ADDENDUM NO. 02

Baggage Screening Improvements – Phase 2B
[Baggage Handling Building Addition and OSR Room]

PROJECT NO. A044-09002-02

DATE OF ADDENDUM: February 07, 2012

A002B

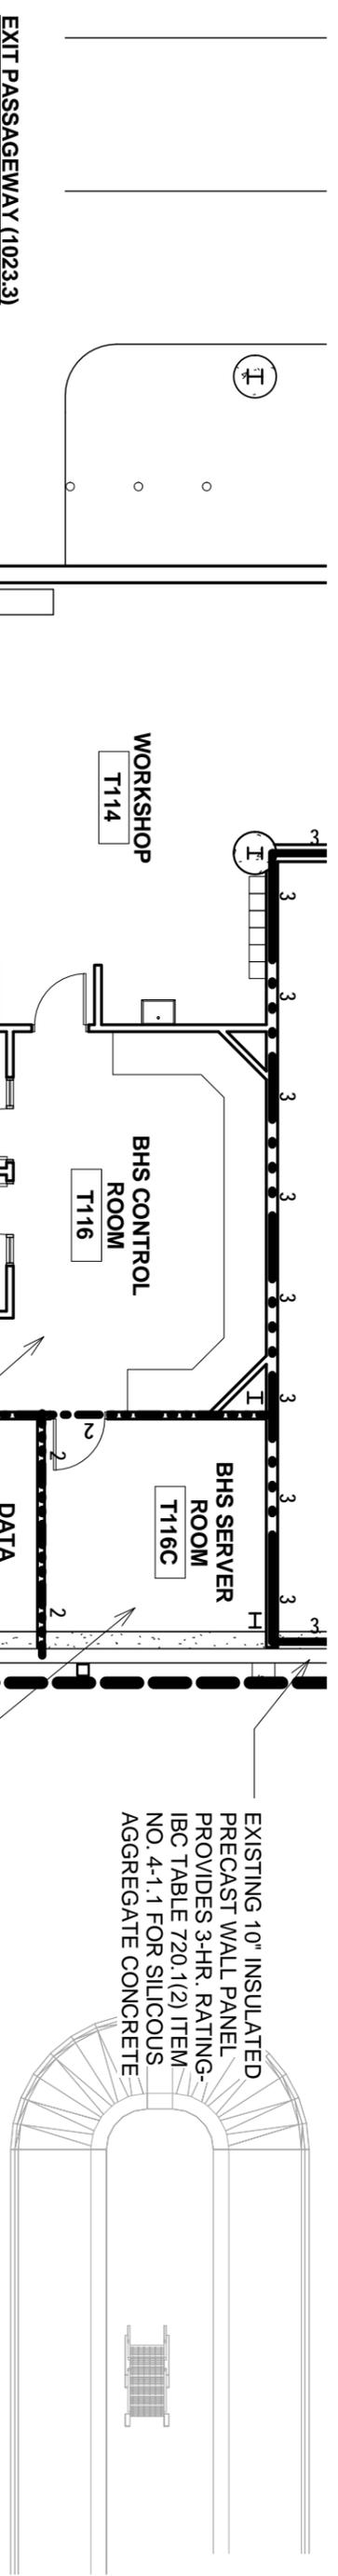
Item: Code plan information, **ADD**: Fire sprinklering note to the existing baggage make up north & south rooms, as shown on supplemental detail A002B attached.

A003B

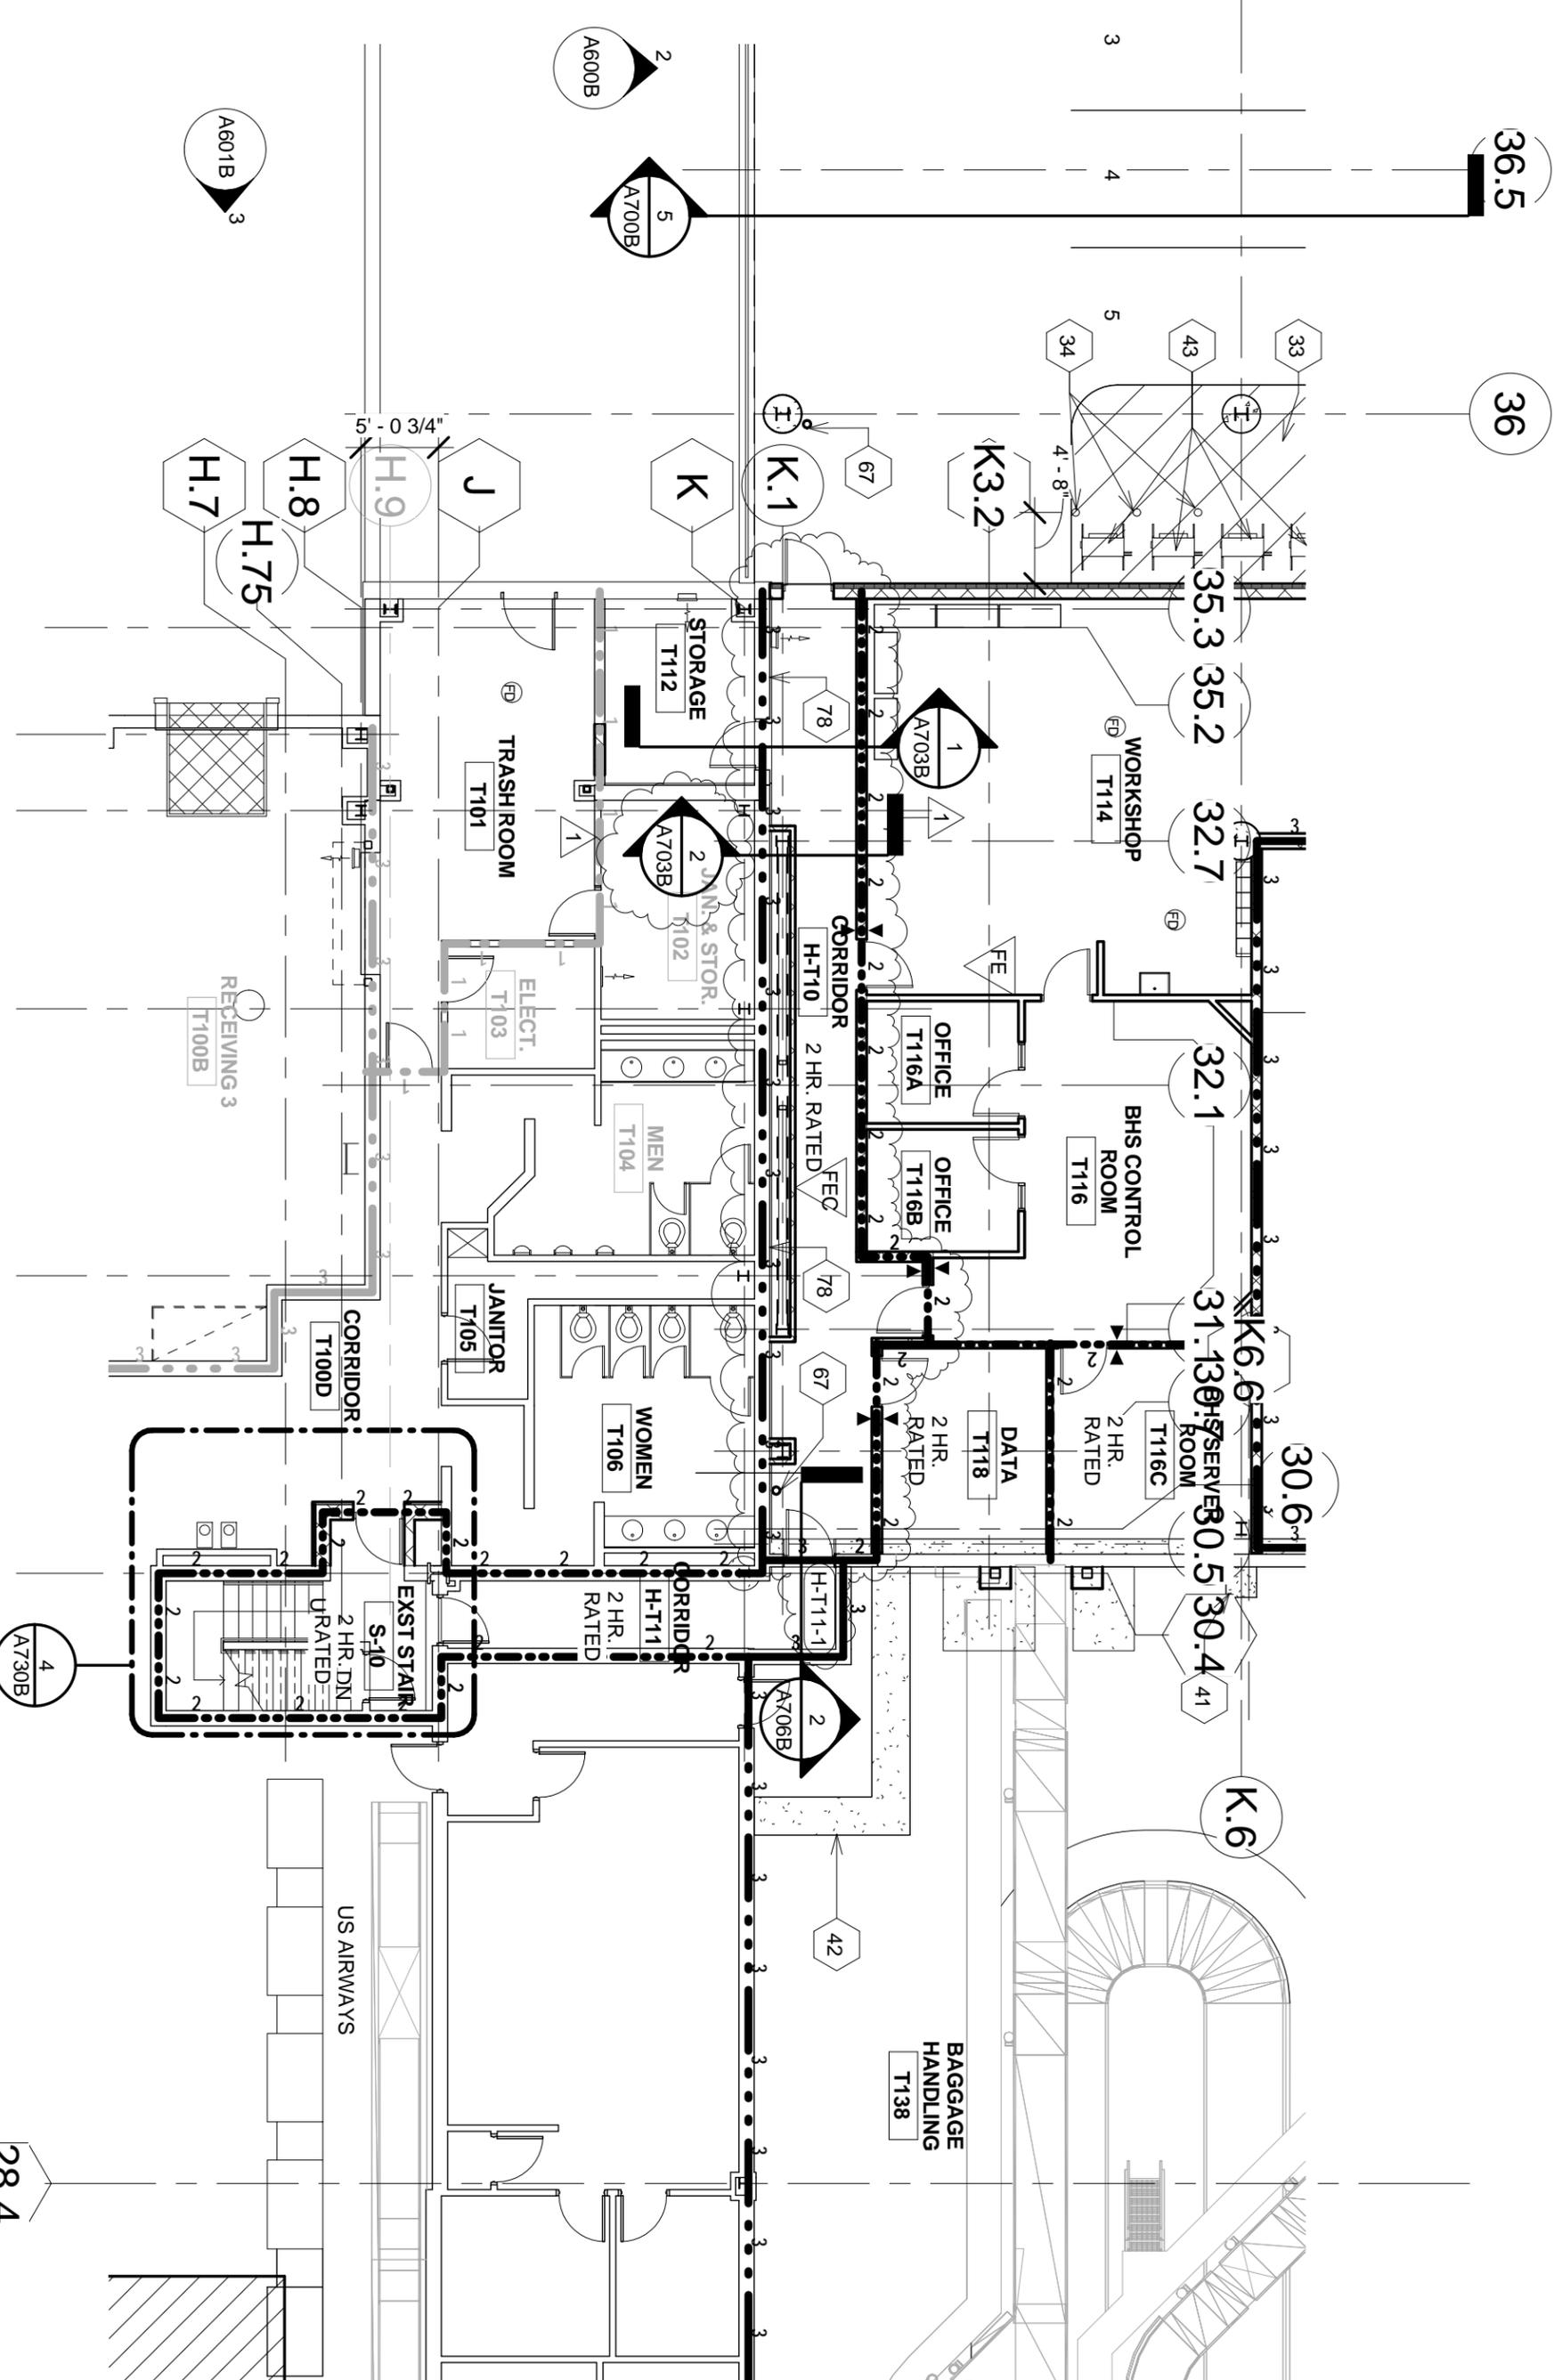
Item: Code plan information, **CHANGE** Existing & new fire barrier ratings to the plan as shown on supplemental detail A003B attached. (East wall of corridor H-T110 changes from 3 hr rating to 2 hr rating). (West wall of corridor H-T110 changes from 2 hr rating to 3 hr rating).

A101B

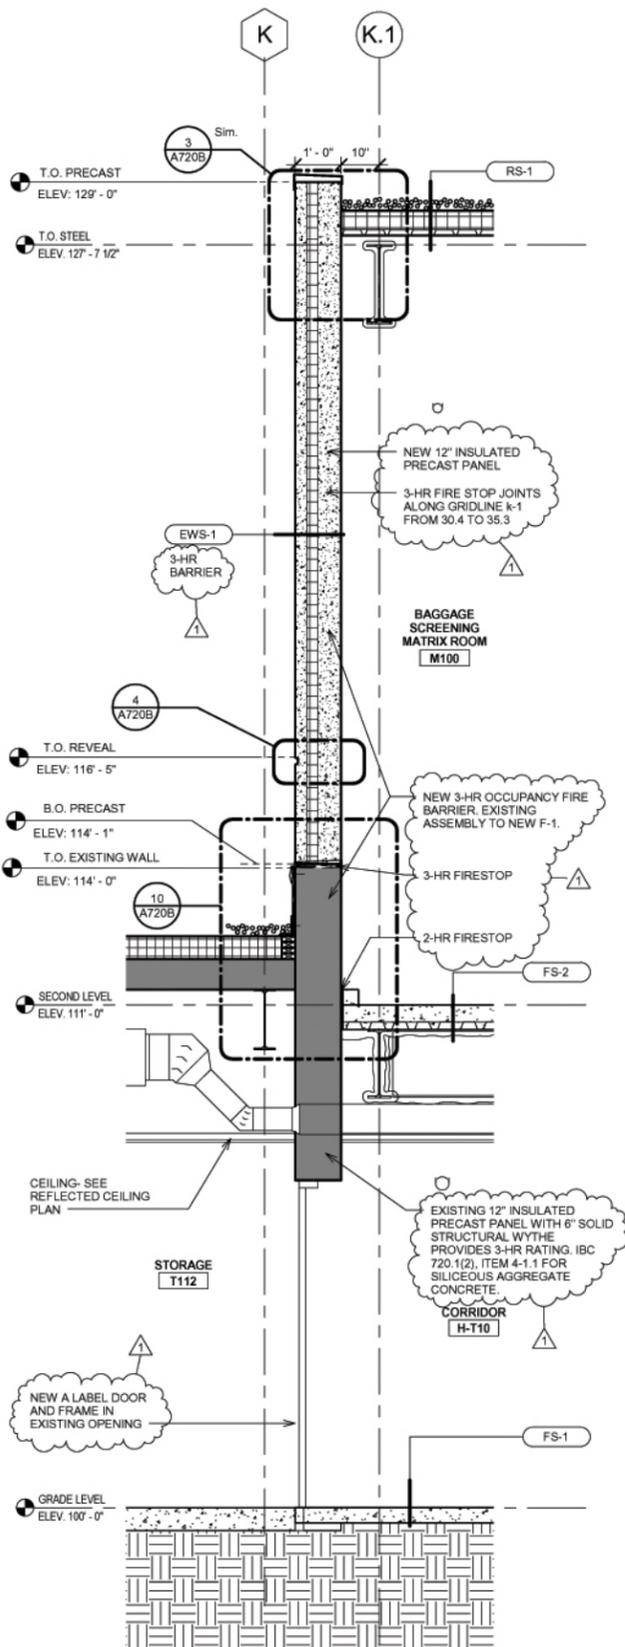
Item: Plan information, **CHANGE**: Existing & new fire barrier ratings to the plan as shown on supplemental detail A101B attached. Add rated passage door H-T11-1 to plan. (East wall of corridor H-T110 changes from 3 hr rating to 2 hr rating). (West wall of corridor H-T110 changes from 2 hr rating to 3 hr rating).

A703B

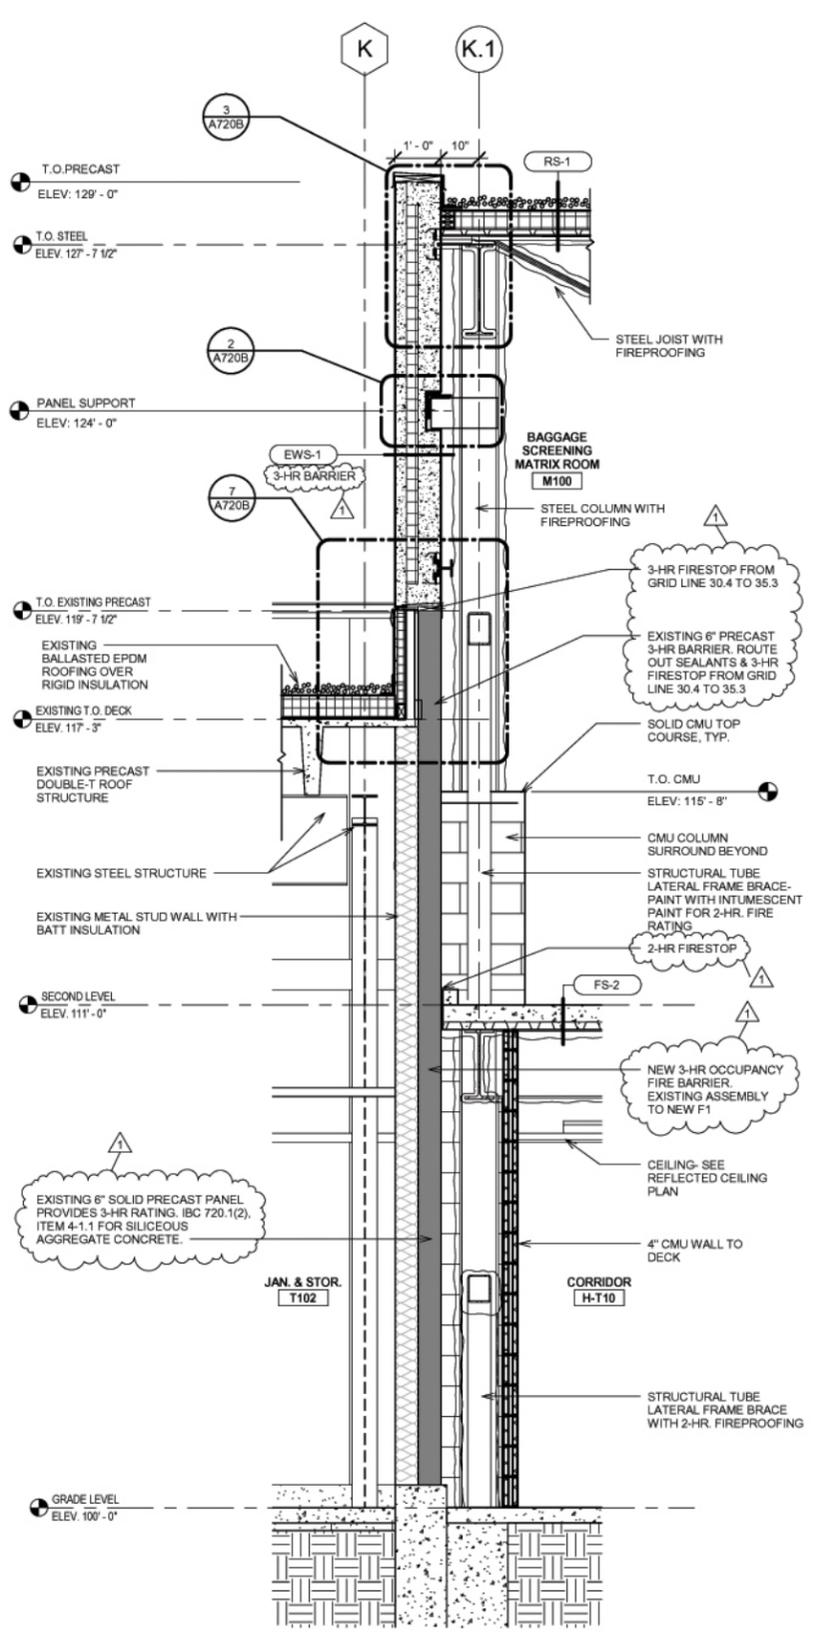
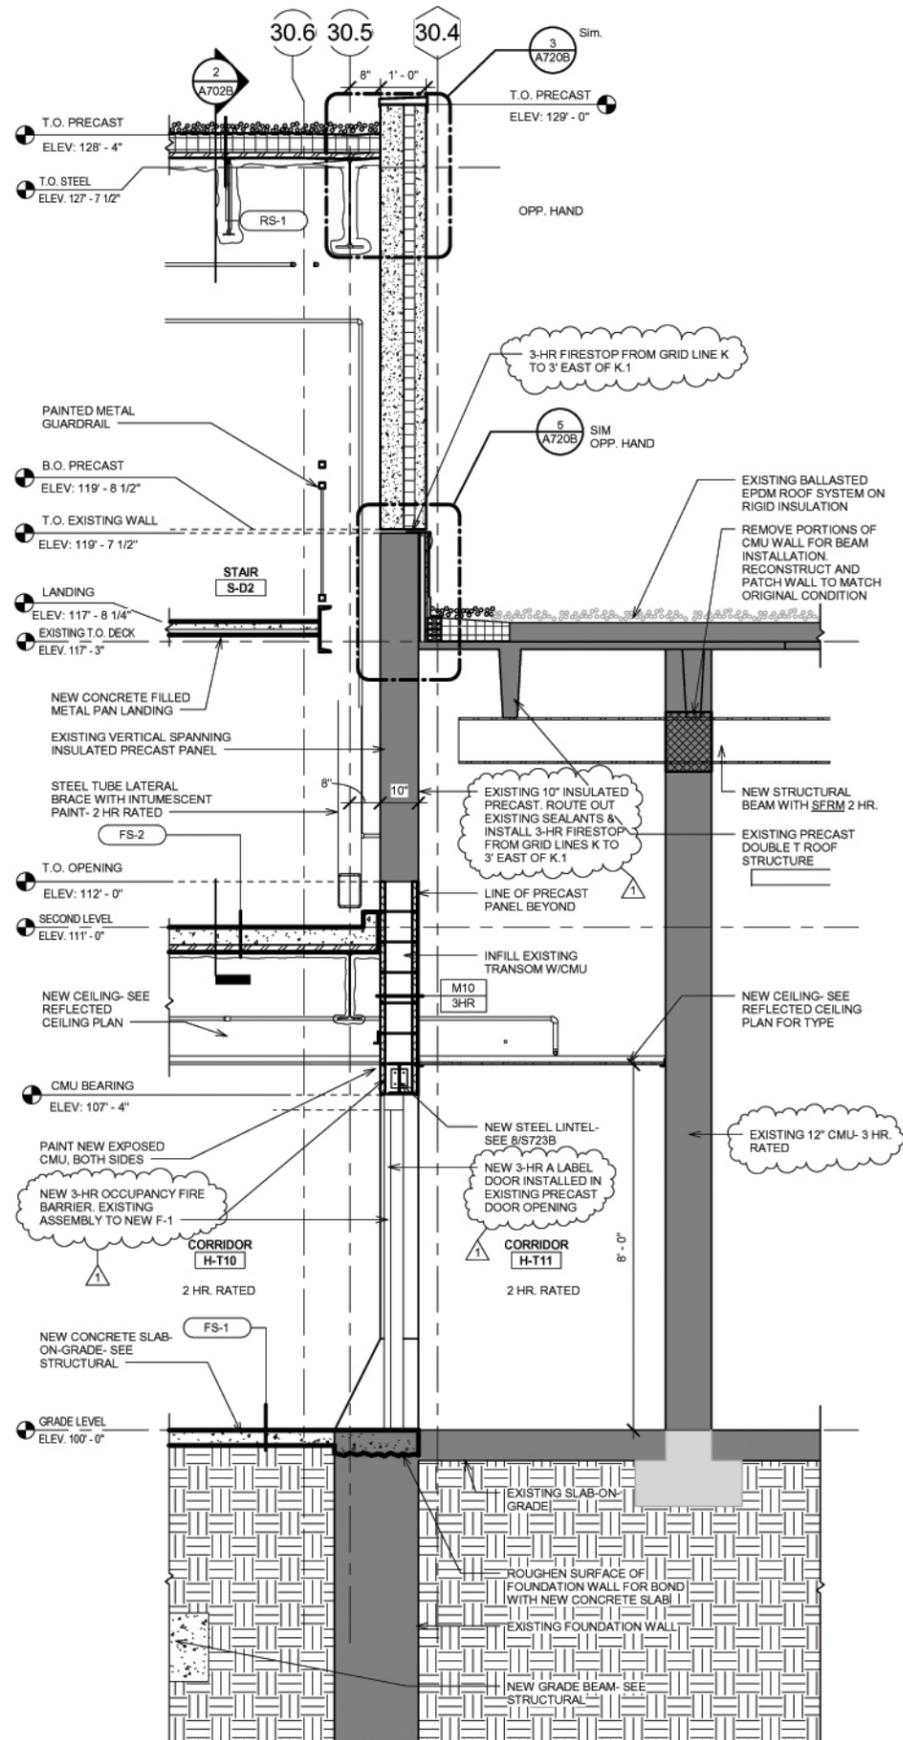
Item: Detail 1 & 2 information **CHANGE**: Existing & new fire barrier ratings to the wall sections as shown on supplemental detail A703B attached. Change door rating. (East wall of corridor H-T110 changes from 3 hr rating to 2 hr rating). (West wall of corridor H-T110 changes from 2 hr rating to 3 hr rating).
